UNITED STATES PATENT AND TRADEMARK OFFICE

APPLICATION NO.	FILING DATE	FIRST NAMED INVENTOR	ATTORNEY DOCKET NO.	CONFIRMATION NO.
10/500,791	07/06/2004	Jose Sevilleja-Perez	OT-4922	8285
26584	7590	07/19/2007		
OTIS ELEVATOR COMPANY INTELLECTUAL PROPERTY DEPARTMENT 10 FARM SPRINGS FARMINGTON, CT 06032			EXAMINER NGUYEN, VU Q	
			ART UNIT 3683	PAPER NUMBER
			MAIL DATE 07/19/2007	DELIVERY MODE PAPER

DETAILED ACTION

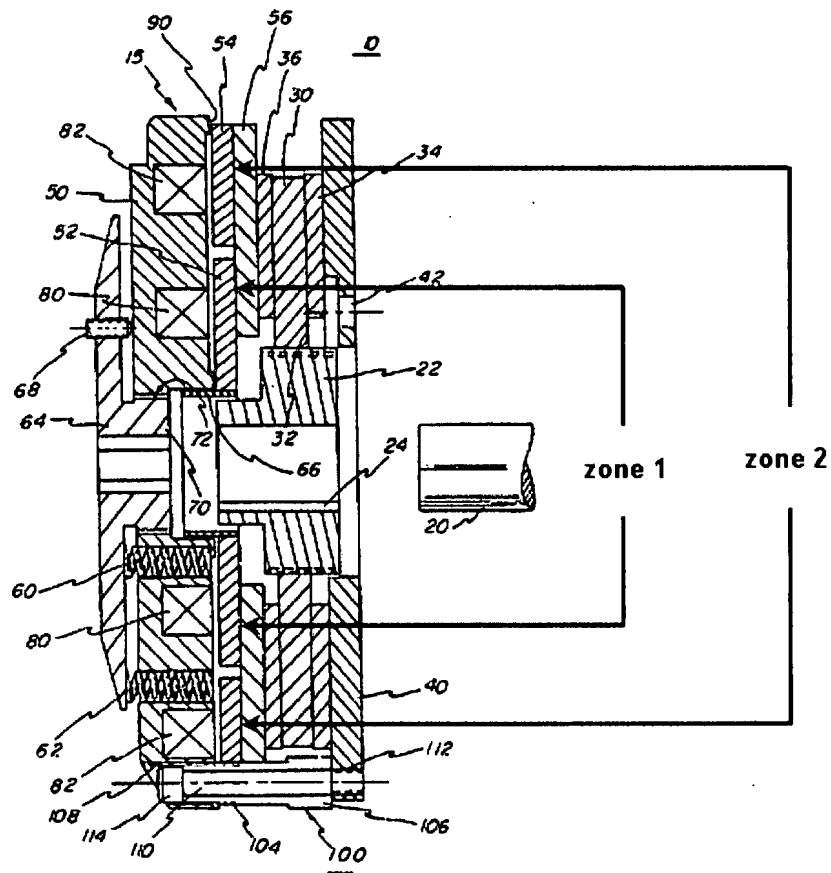
Regarding claim 1, Dammeyer et al. disclose a brake (capable of use with an elevator), comprising: a rotor (30); movable first and second brake plates (52, 54), the first and second brake plates being independently actuatable (column 3, line 46 - column 4, line 20) into engagement with a different one of two zones (as broadly recited, see figure below) on one side (left side, Fig. 3) of the rotor.

Regarding claim 5, see Figs. 1 and 2 and figure above.

Regarding claim 6, see front brake lining 36 and figure above.

Regarding claim 7, see Fig. 1 and the non-integral front brake lining 36 with portions disposed (as broadly recited) on each of the concentric annular zones (see figure above).
